UDPRP Review Summary

Urban Design Peer Review Panel

PROJECT: Rivulet Development

Exhibit 2

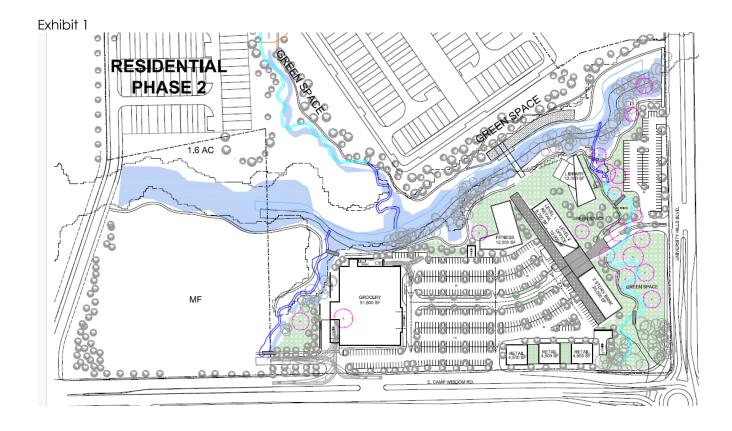
- 10. The Panel suggests looking at a circulation system that connects all quadrants of the intersection that allows the site to grow and evolve over time. (Applicant Response 10.16.23) As mentioned prior, subject to discussions with City of Dallas Transportation Department, the University Hills intersection re-design will ease pedestrian access to/from the UNT campus via some combination of round-about, striping, lighting, parallel parking and/or bike lanes. We also plan to discuss with Transportation the possibility of additional pedestrian crossings to the site at other locations along Camp Wisdom and University Hills; new/additional signals/stop signs and striping would be required to safely cross CW and UH. (City Response 10.23.23) Your intent to work with the City's Transportation department on a design of a safer intersection satisfies the Panel's recommendation. Please provide updates to intersection design discussions and plans as they are developed to ensure the proposed changes to intersection are achieving the goals set by the UDPR Panel's recommendations
